ENVIRONMENTAL
IMPACT
REPORT

Addendum

Volume 2B: Response To Comments

1988
Revision
to
the
Air
Quality
Management
Plan

FIGURE 1. Annual NO₂ concentrations projected using the AQMP modeling methodology.

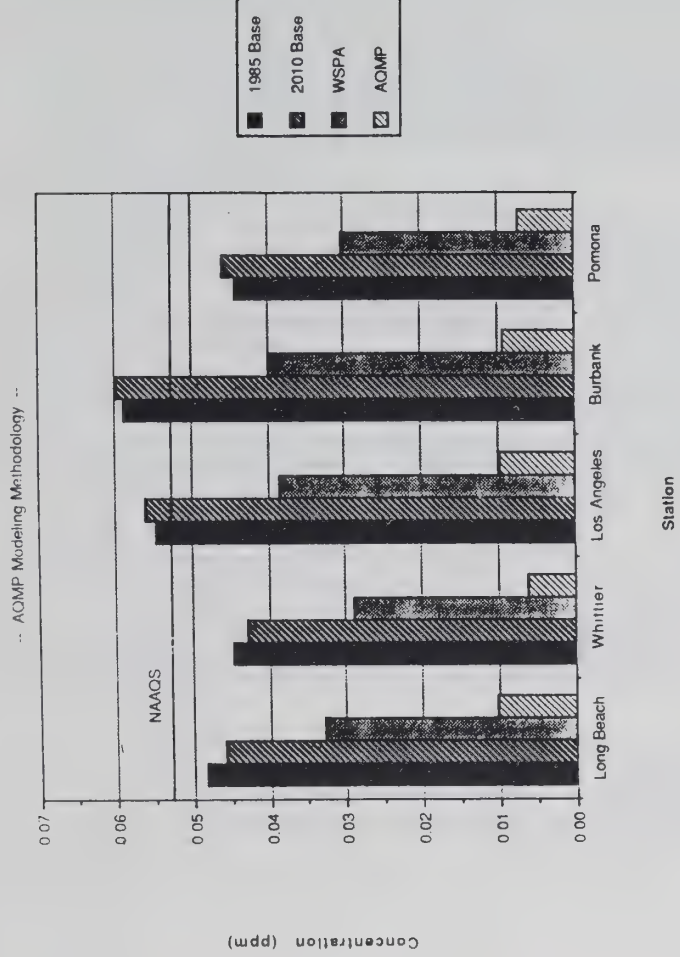
Figure 1 presents the results of these calculations at the same five stations highlighted in AQMP Appendix V-A: Long Beach, Whittier, Los Angeles, Burbank, and Pomona. These stations include Burbank and Los Angeles, the stations that have measured the highest current NO₂ levels and are projected to have the highest 2010 baseline NO₂. For comparison, baseline 1985 and 2010 levels are shown, along with the projected AQMP concentration.

FIGURE 2. 24-hour average PM10 design values at Rubidoux for 1985-1987, for different EPA-acceptable calculation methods.

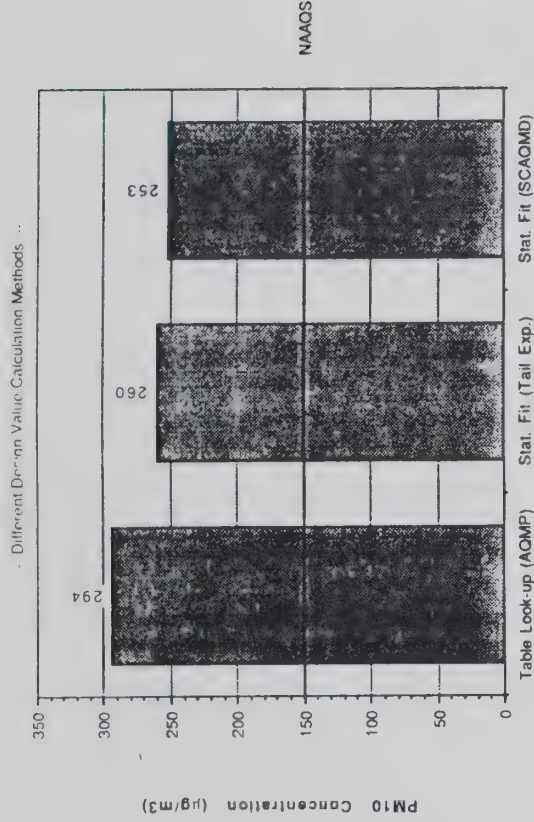
Different design values are obtained using the different calculation methods above. The effect of the design value calculation method was investigated for several alternative approaches. PM10 data from 1985-1987 at Rubidoux were used to estimate the design value obtained with the table look-up procedure and with two statistical distribution fits. Figure 2 compares those design values. The bars in that figure (left to right) represent the design values calculated using:

In summary, the table look-up method used in developing the draft AQMP appears to be acceptable under EPA PM10 SIP guidelines. However, as demonstrated in the figure, alternative, equally EPA-acceptable methods could also be used that would significantly lower the PM10 design value, and consequently the degree of control required to demonstrate attainment of the federal 24-hour standard. The difference at Rubidoux could be as much as 14 percent (from $294 \mu\text{g}/\text{m}^3$ down to $253 \mu\text{g}/\text{m}^3$).

FIGURE 3. Example nitric acid isopleth diagram and illustrative control strategy analysis.

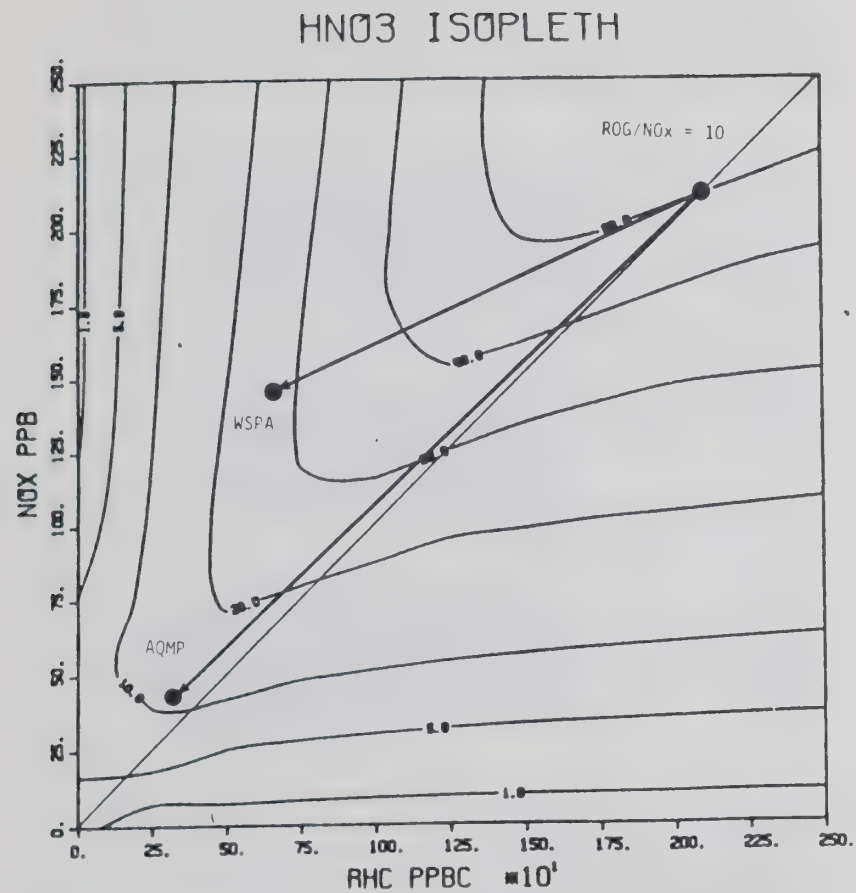
Pending completion of UAM analyses, the magnitude of the ROG effect on PM10 is unknown. However, the direction and general significance of the effect can be broadly assessed, at least in a qualitative way. Figure 3 reproduces a nitric acid isopleth diagram reported in AQMP Appendix V-M. Using this diagram in an analogous manner to the use of ozone isopleth diagrams in EPA's Empirical Kinetic Modeling Approach (EKMA), the extent of peak-hour nitric acid reduction under the AQMP and the WSPA plan can be approximated. For discussion purposes, diagram entry can be accomplished by assuming a typical SOCAB ROG/ NO_x ratio (assumed for discussion to be 10:1) and defining the entry point to be the intersection of that ratio with an arbitrary 1-hour peak nitric acid value of 50 ppb.

Figure I-1

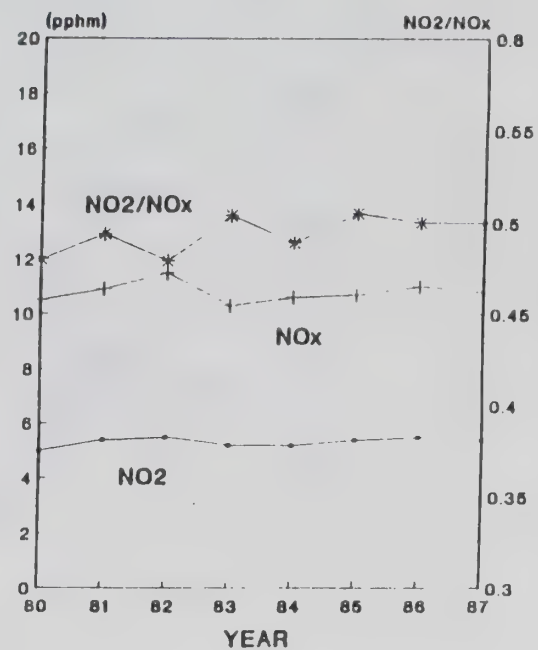
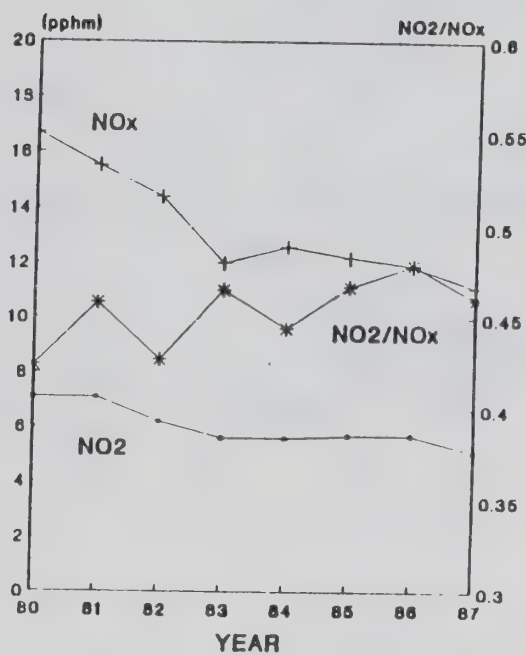
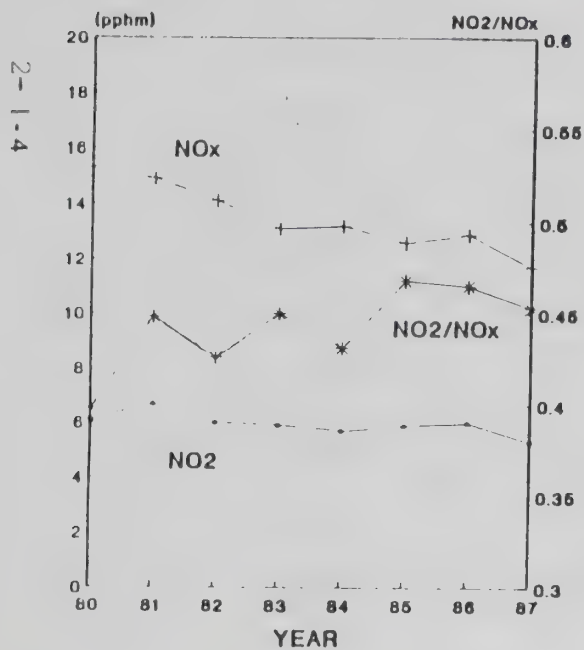
At Pomona, the annual average NO_2 concentration has been increasing as shown in Figure I-1. Although the increasing trend is not statistically significant, it is important to note that it did not follow the general decreasing trend in the central and coastal portions of the Basin. Pomona actually became the station with the worst annual NO_2 air quality in the Basin during 1987.

FIGURE I-2
 Increases of NO_x emissions During 1985-2010
 In The South Coast Air Basin Without Further Control
 (Emission Decreases are not shown)

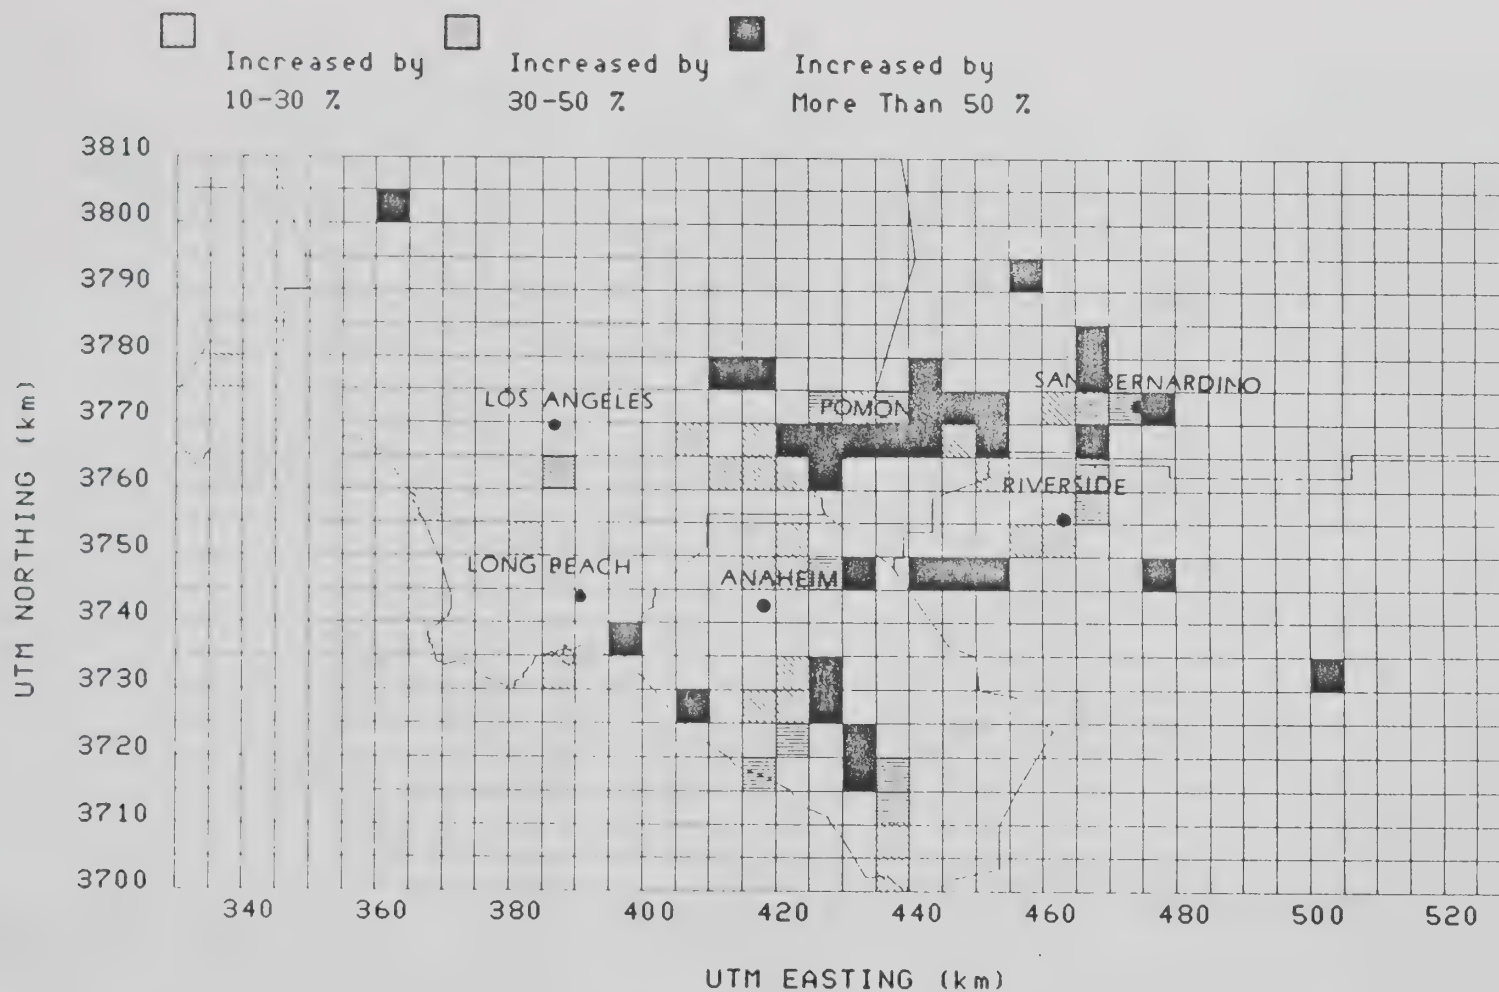
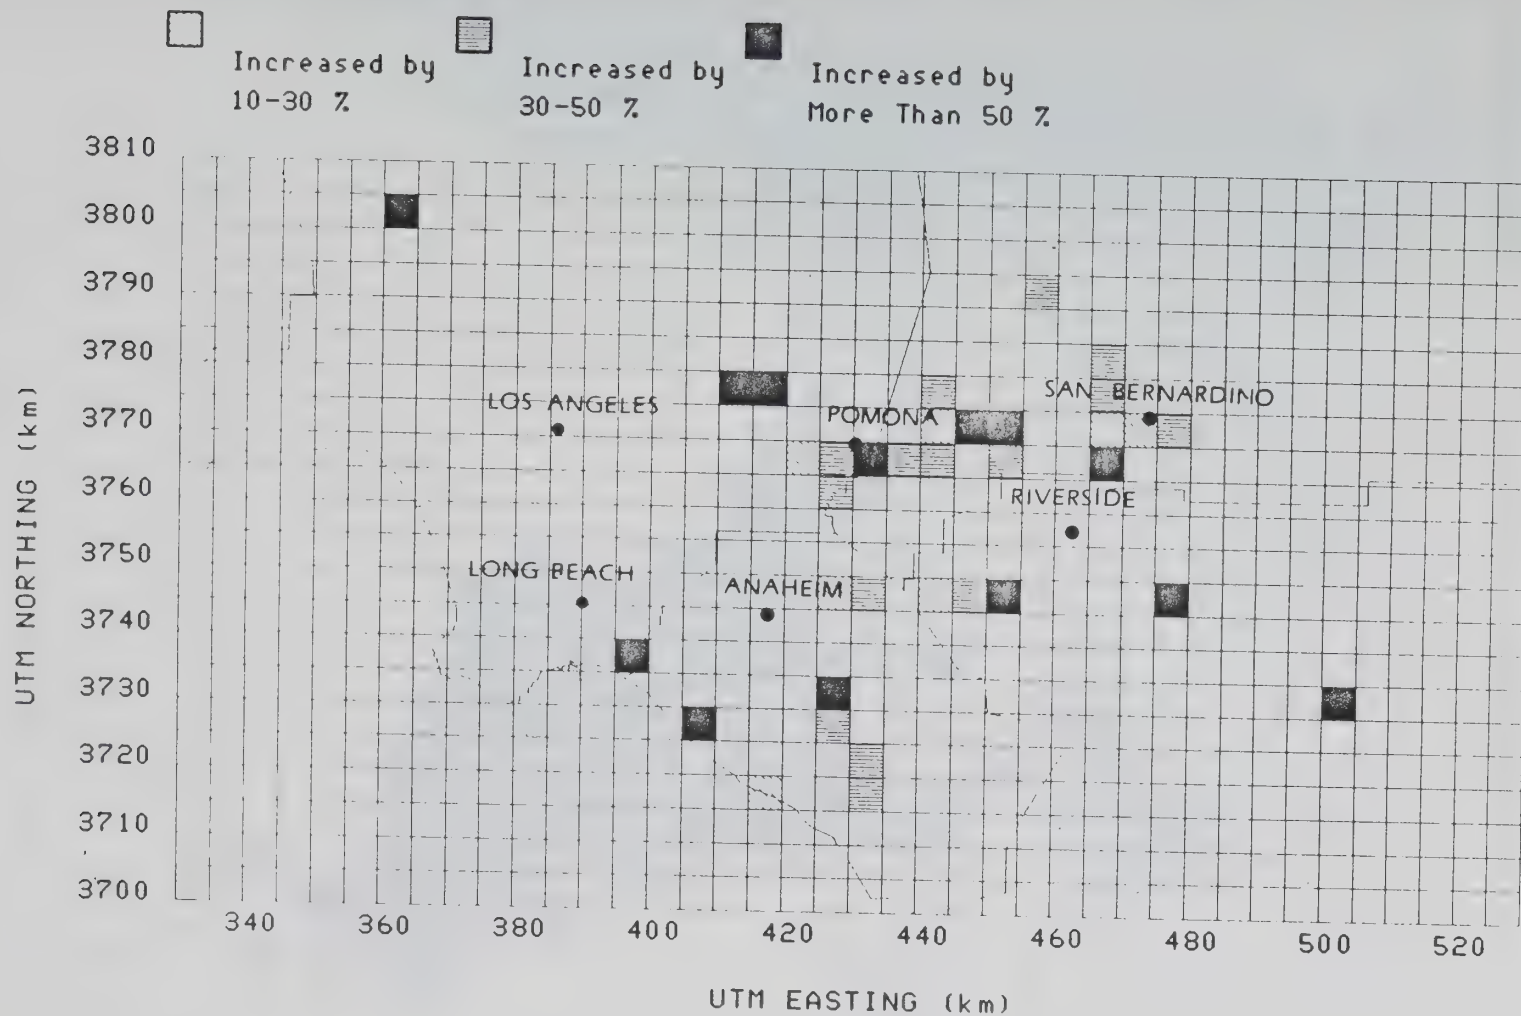
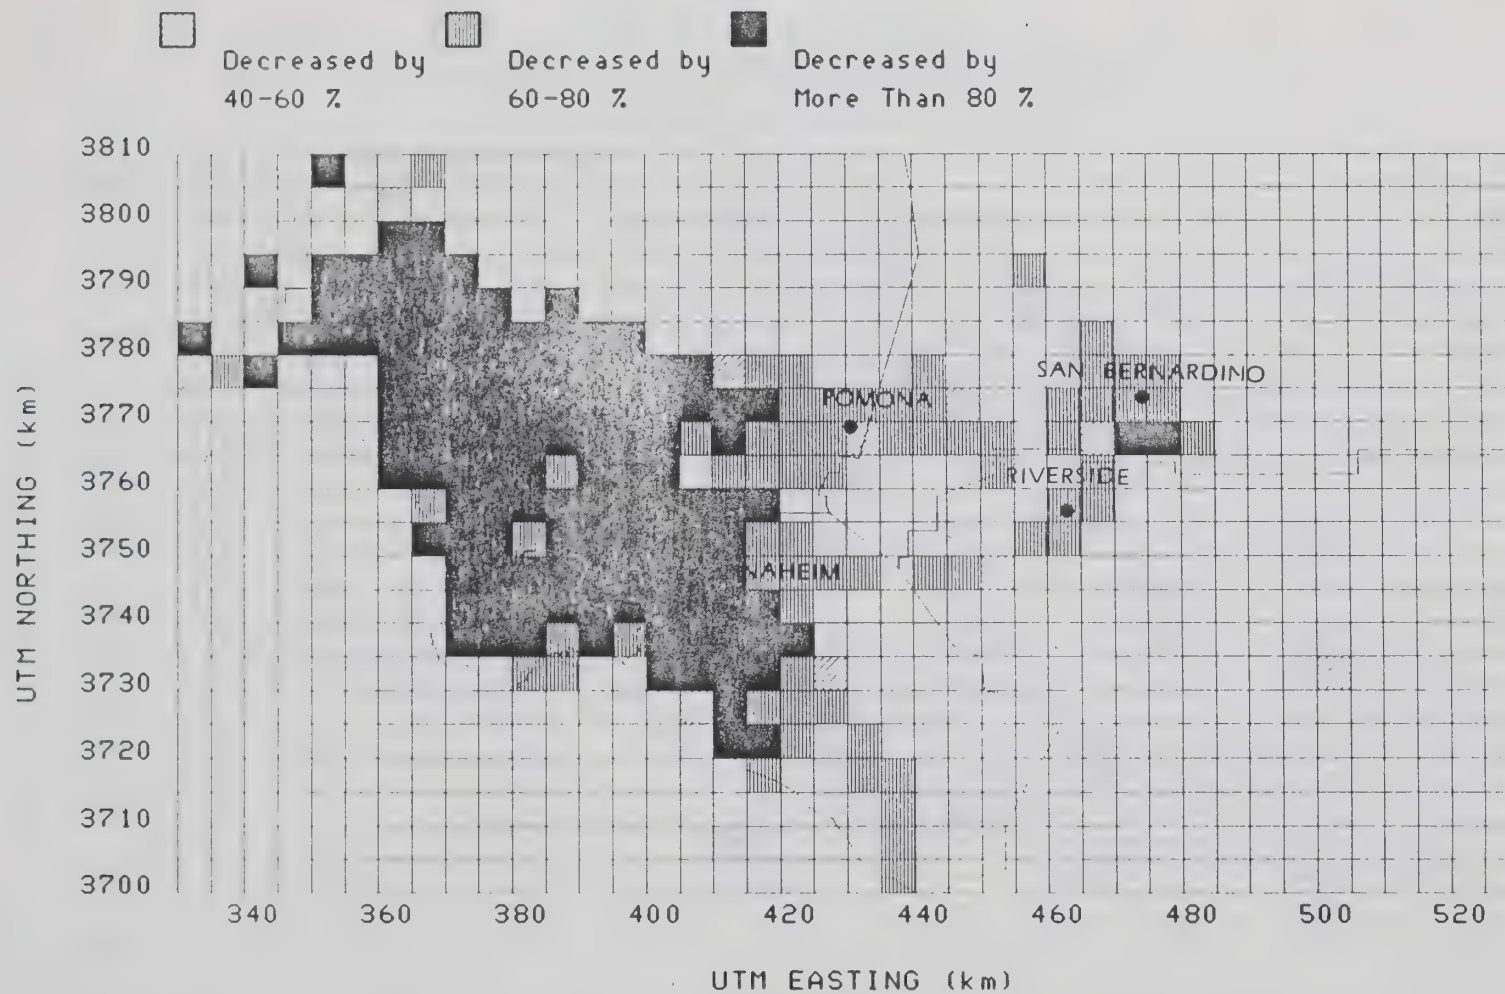
Figures I-2 and I-3, illustrate projected NO_x emissions increases between 1985 and 2010 for the base case (without further control) and the industry plans, respectively. Figure I-4 illustrates the projected emissions decreases corresponding to the District 1988 AQMP Revision; no NO_x emissions increase is expected anywhere in the Basin for this case. As can be seen in Figure I-3, under the industry proposals, NO_x emissions on the east side, particularly around Pomona, increase significantly.

Since previous NO_x emissions reductions in the western region have not caused a concurrent reduction of NO_2 concentrations in the Pomona area, the emissions changes shown in Figure I-3 would lead one to conclude that the SCE and WSPA plans will leave the Pomona area out of compliance with the federal NO_2 standard. In contrast, referring to Figure I-4, the District's plan would result in NO_x emissions reductions in both the west and east regions and therefore would achieve compliance. These conclusions are consistent with the modeling results discussed earlier.

FIGURE II-1
Projected annual average PM10 concentrations

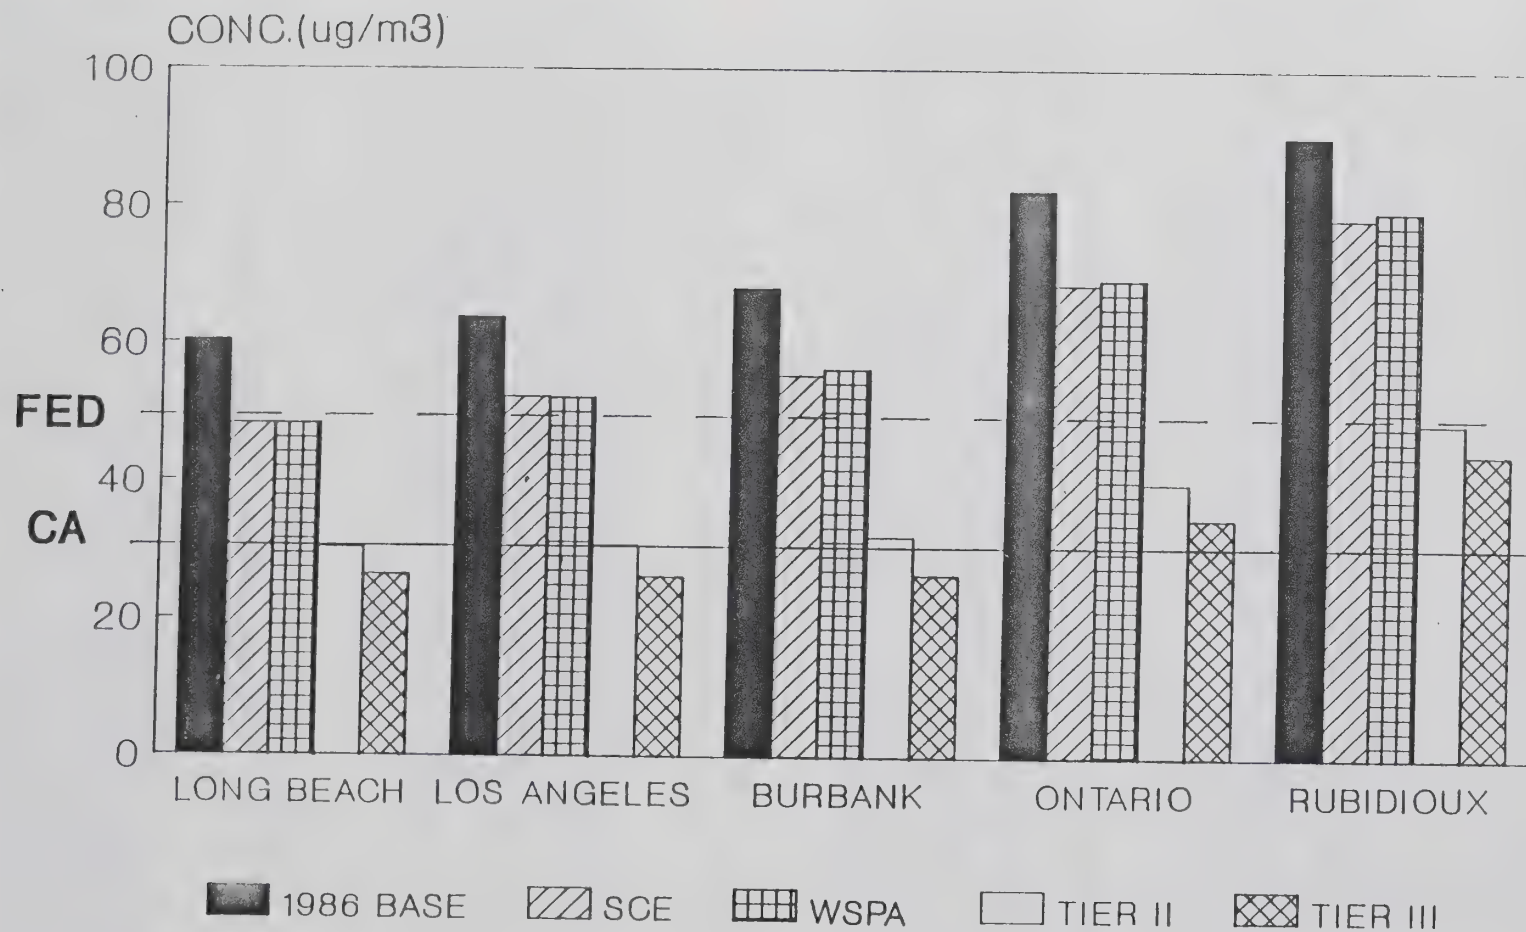
Figure II-1 shows that both the SCE and WSPA control strategies will not bring the Basin into compliance with the federal and state annual PM10 standards. It is expected that the annual standard will be exceeded at most locations in the Basin under either of these control plans. The District's Tier II control scenario is expected to reduce PM10 concentrations sufficiently for the federal standard to be met at all locations, but not the state standard. Tier III control will bring the western locations into compliance with the state standards, while the eastern sites will still require some further reductions.
